# DUTCH BROS. COFFEE - CO0707 - PEYTON, CO INITIAL EROSION CONTROL PLAN

INITIAL EROSION CONTROL PLAN  
 7520 FALCON MARKET PLACE  
 PEYTON, CO 80831

# DUTCH BROS. COFFEE - CO0707 - PEYTON, CO FINAL EROSION CONTROL PLAN

# DUTCH BROS. COFFEE - CO0707 - PEYTON, CO EROSION CONTROL DETAILS

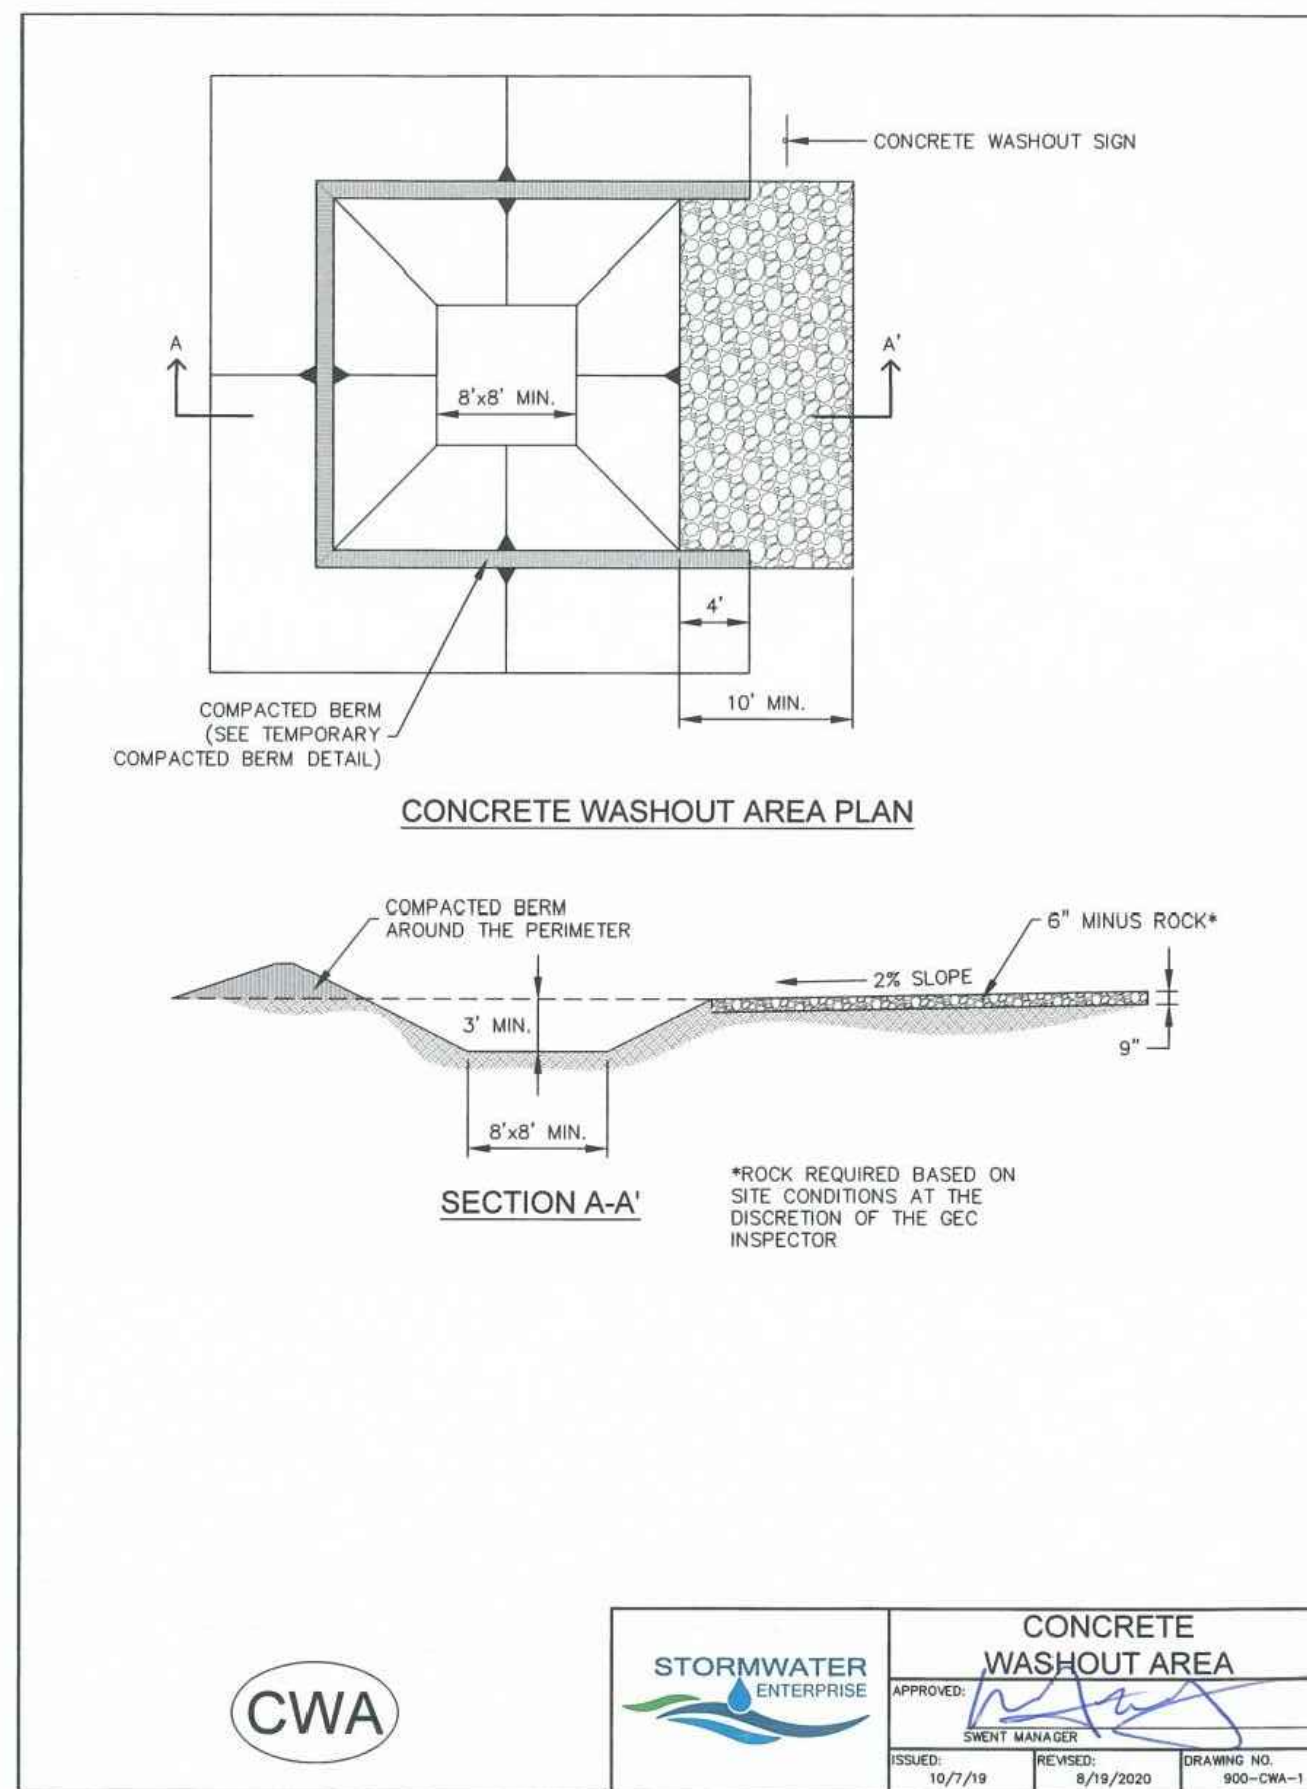
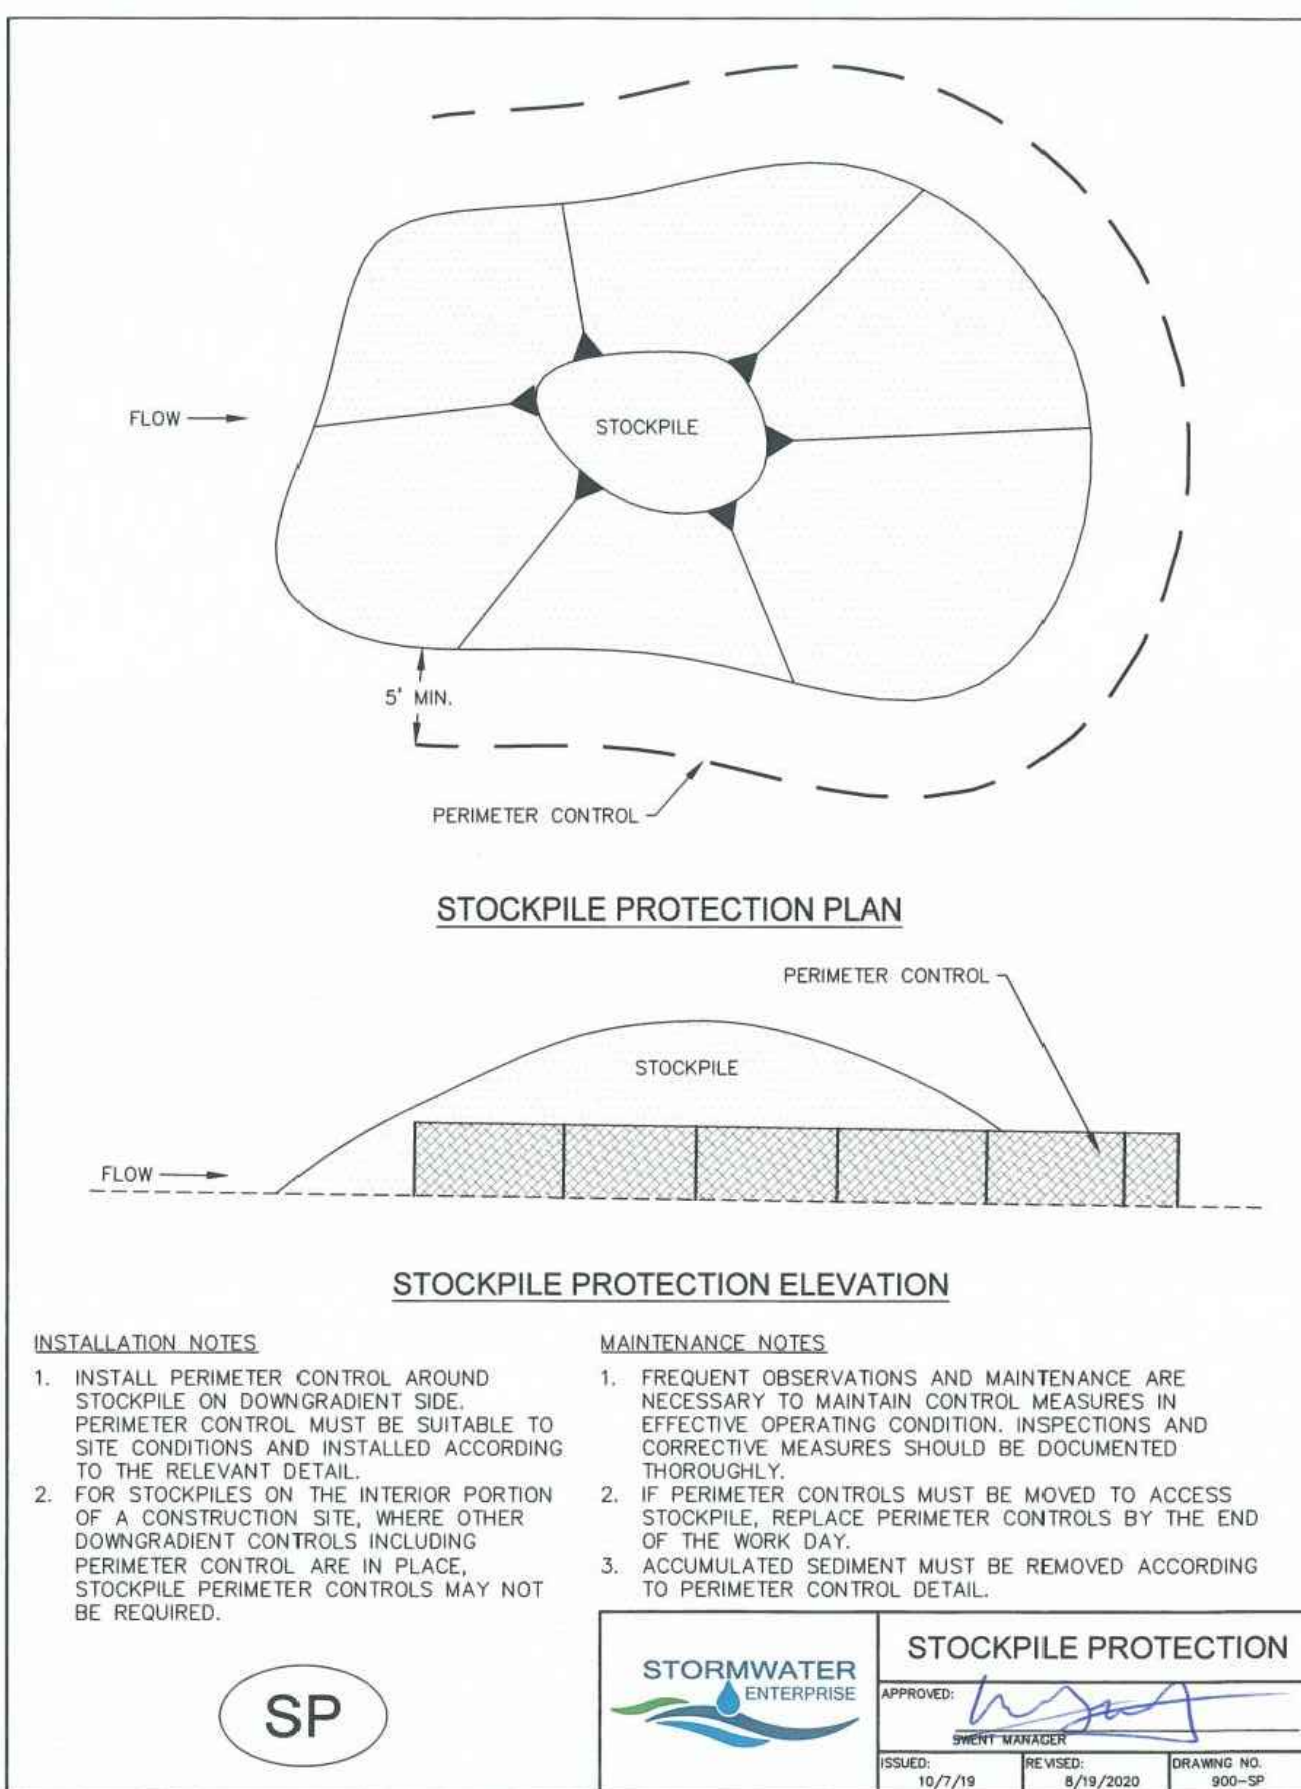
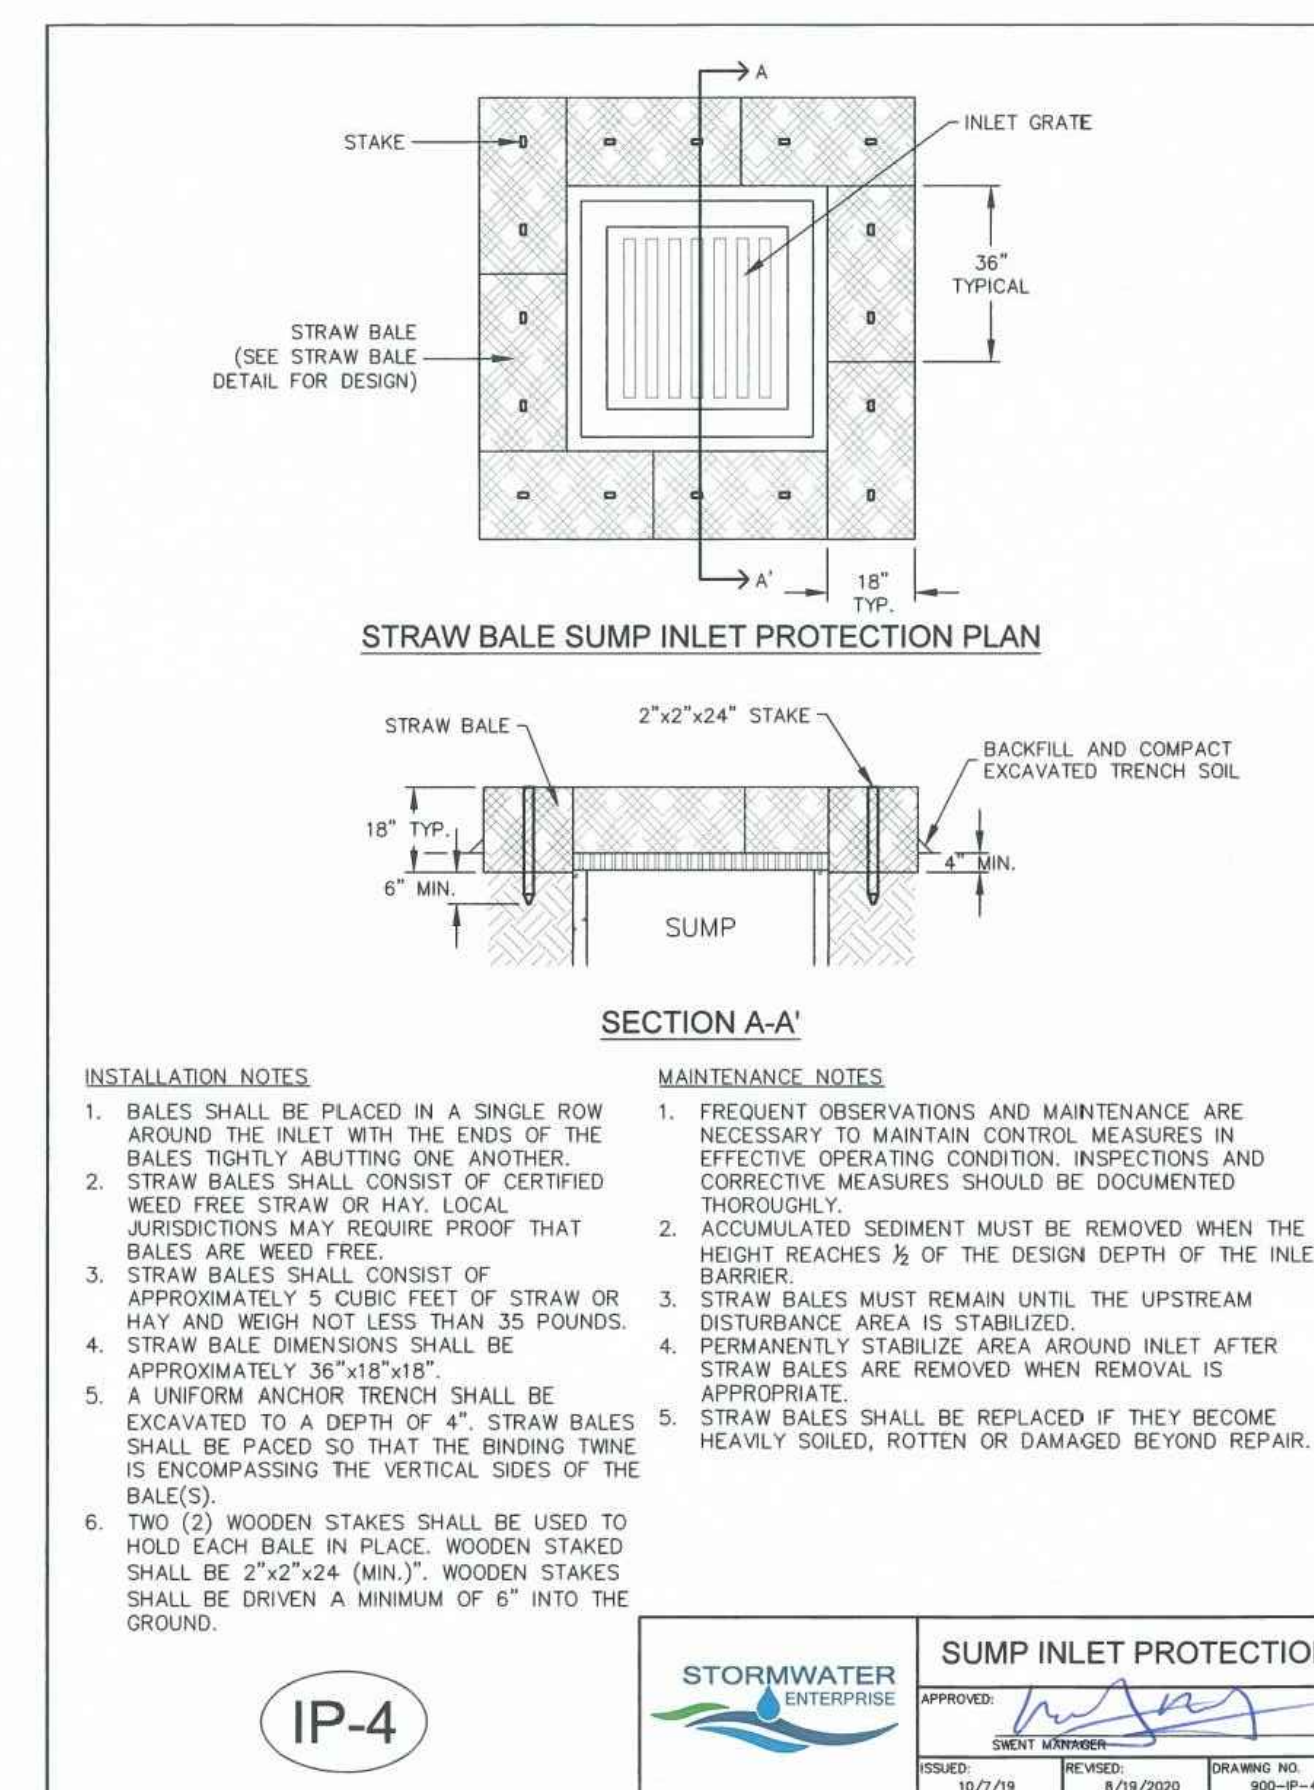
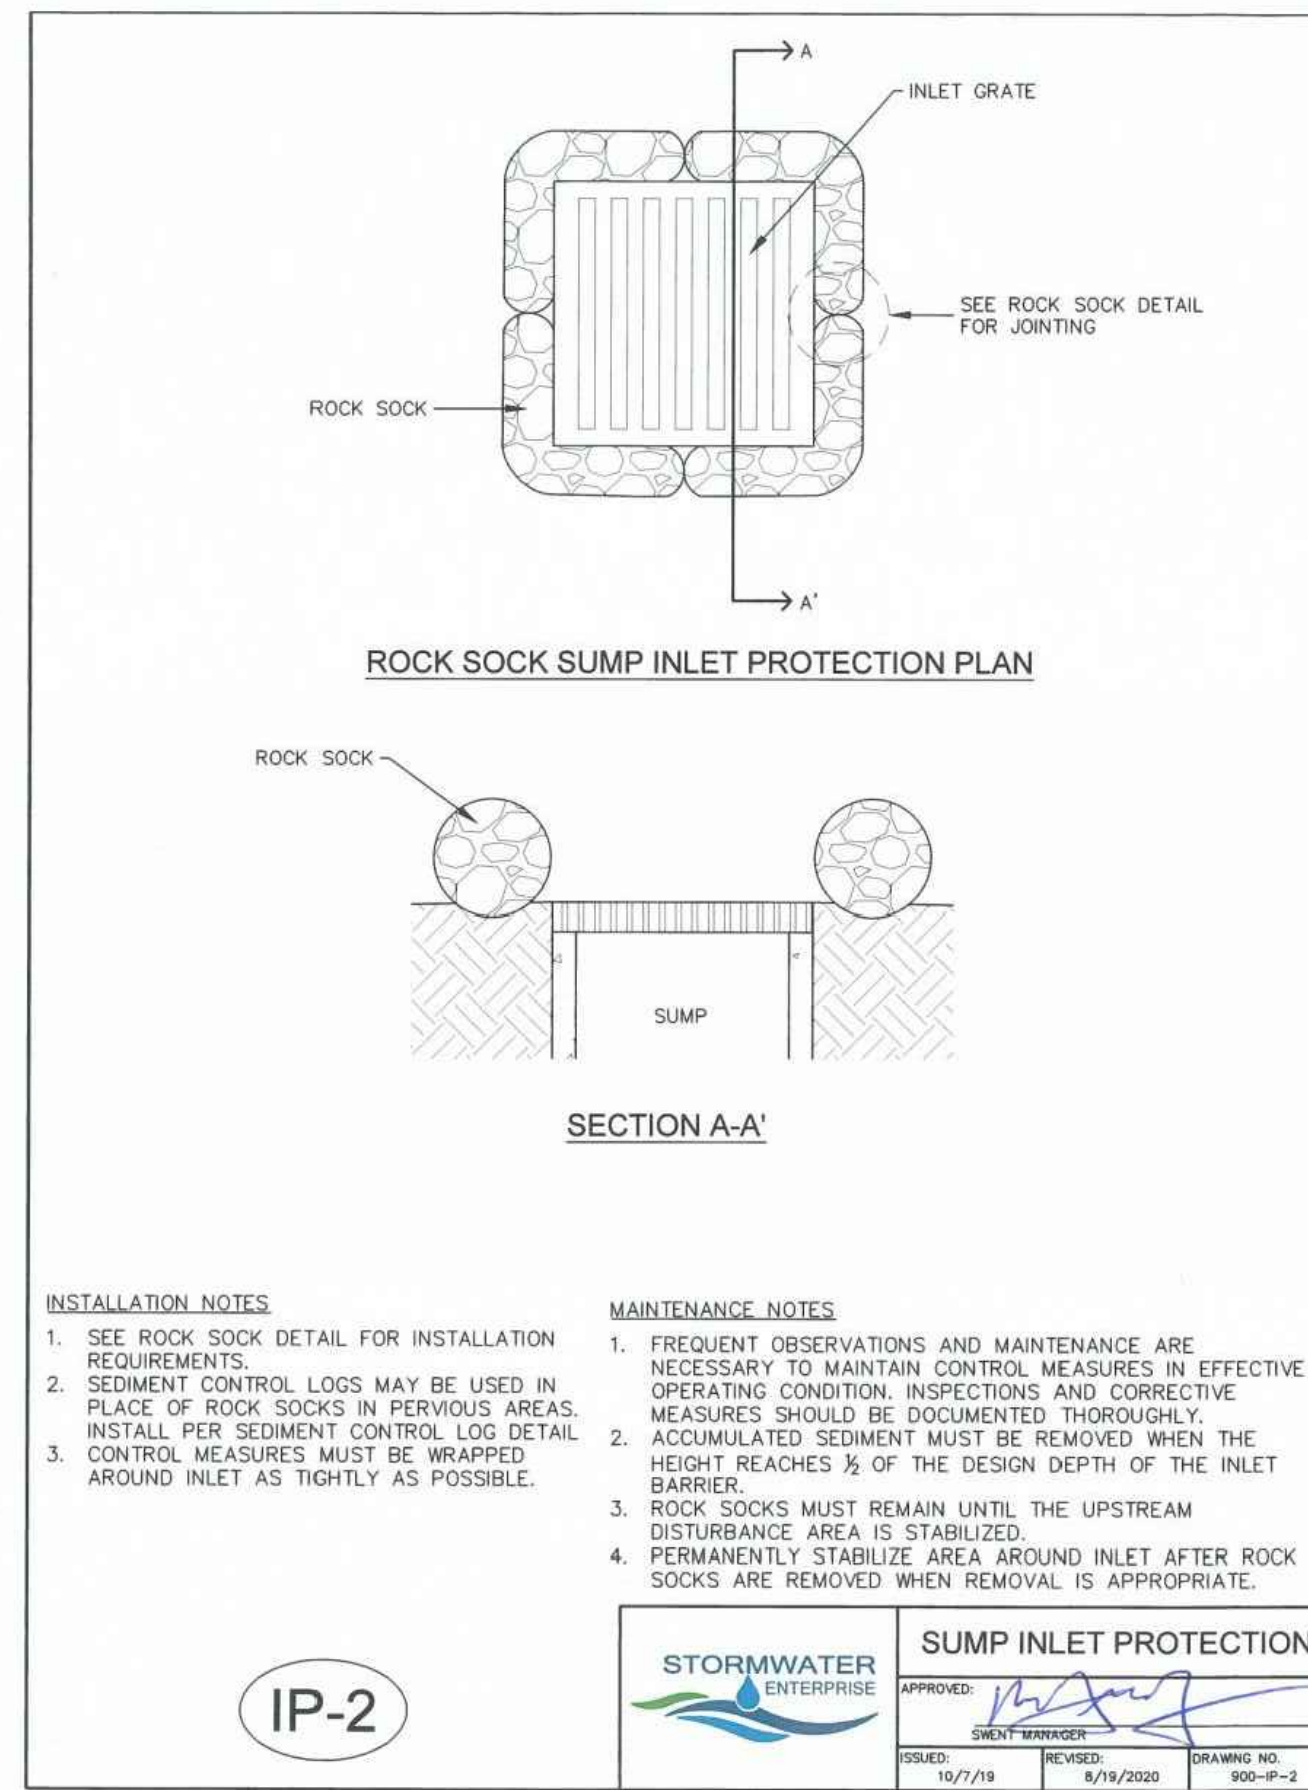
provide details for waddles and check dams
